WILLIAMSON COUNTY, TEXAS
CHANGE ORDER NUMBER: 32

Project: 09WC720

Roadway: US 183

**US 183 Riva Ridge Drive to SH 29
Williamson County Project No. 09WC720**

SHEET 1 OF 8

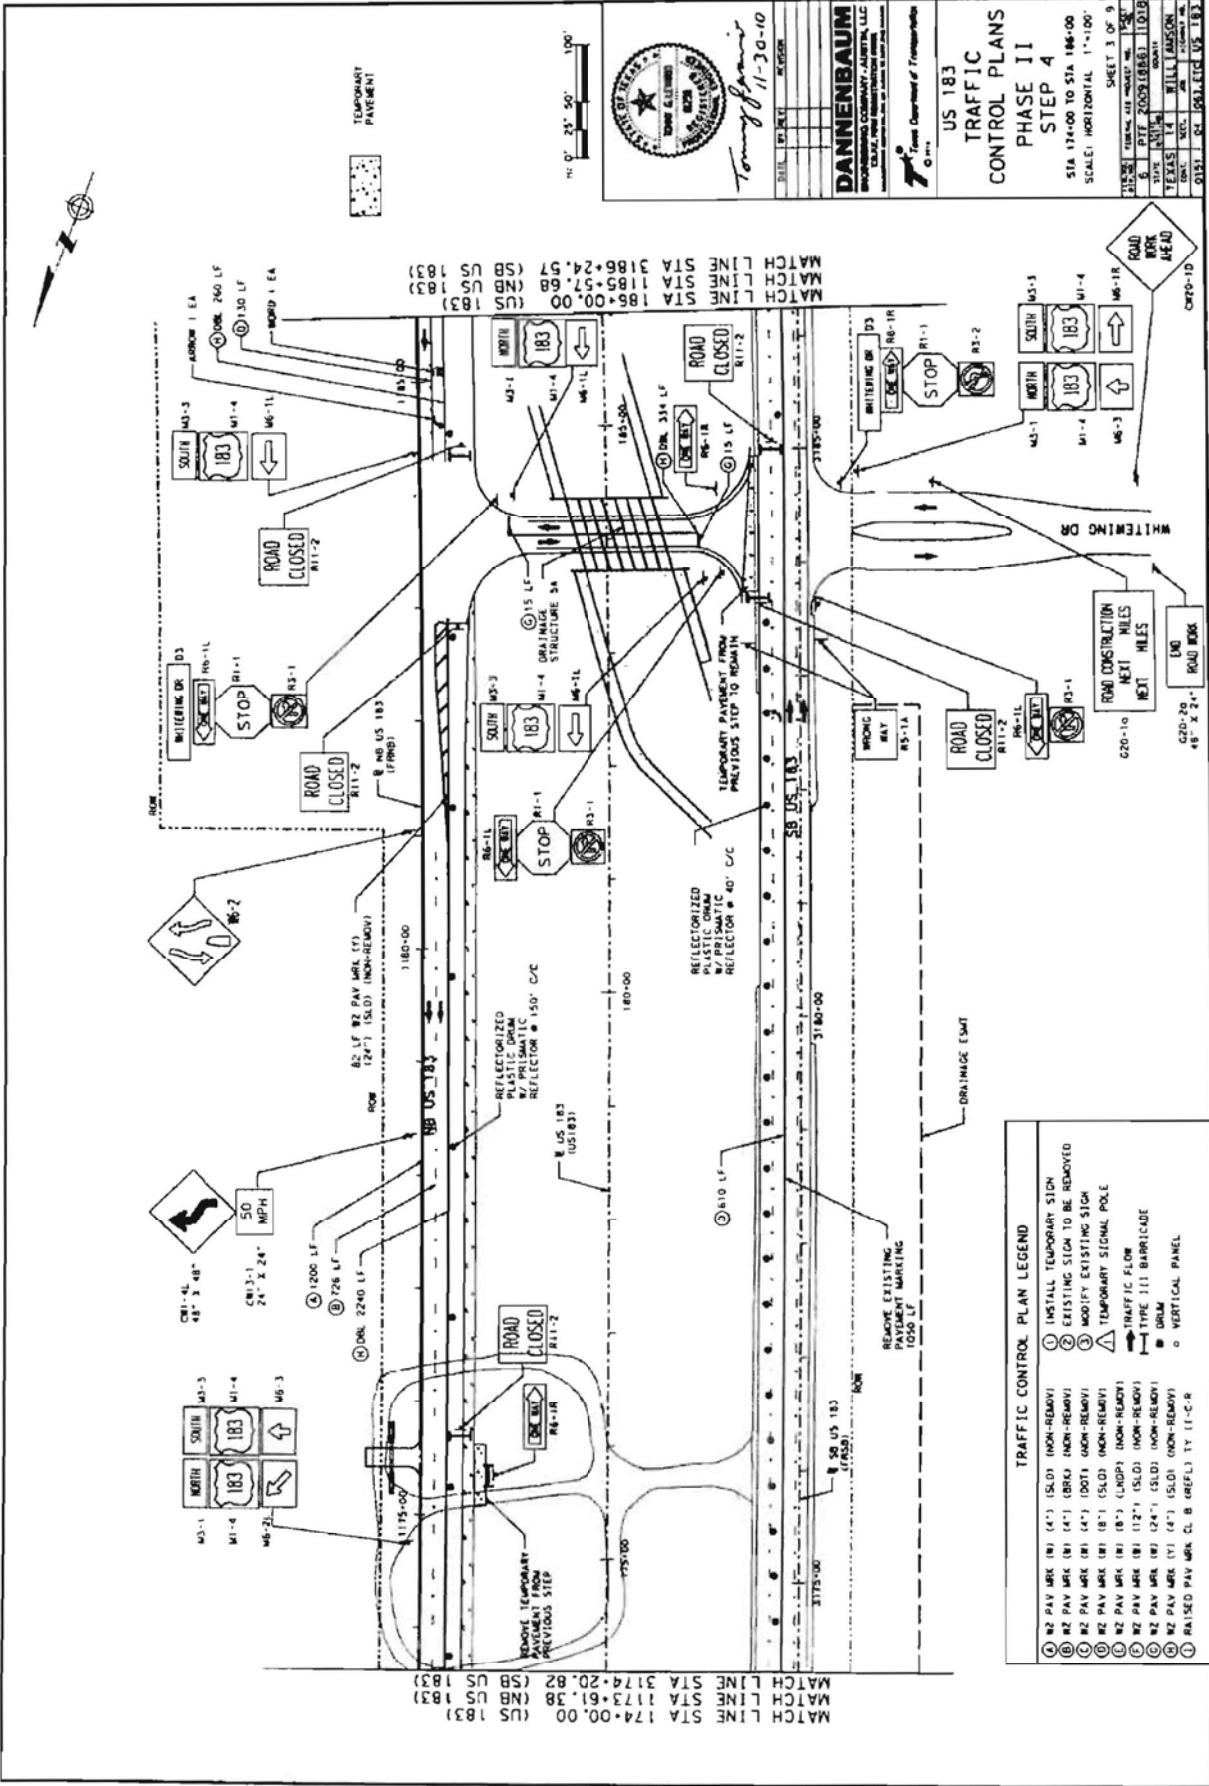
2G: Differing Site Conditions (unforeseeable). Unadjusted utility (unforeseeable). This Change Order compensates the Contractor for additional pavement striping items required by changes in the phasing of the Traffic Control Plans due to unadjusted utilities. The changes in phasing allowed the Contractor to continue construction and avoid the unresolved utility conflicts. **1A: Design Error or Omission. Incorrect PS&E.** This Change Order compensates the Contractor for pavement striping related work items that were not included in the original contract quantities to provide for temporary tabs during SMA paving operations.

6. Work to be performed in accordance with Items: See Attached
7. New or revised plan sheet(s) are attached and numbered: TCP II Step 4 Sht 1-8, TCP II Step 5 Sht 1-9
8. New Special Provisions to the contract are attached: ☐ Yes ☒ No
9. New Special Provisions to Item N/A No. N/A, Special Specification Item N/A are attached.
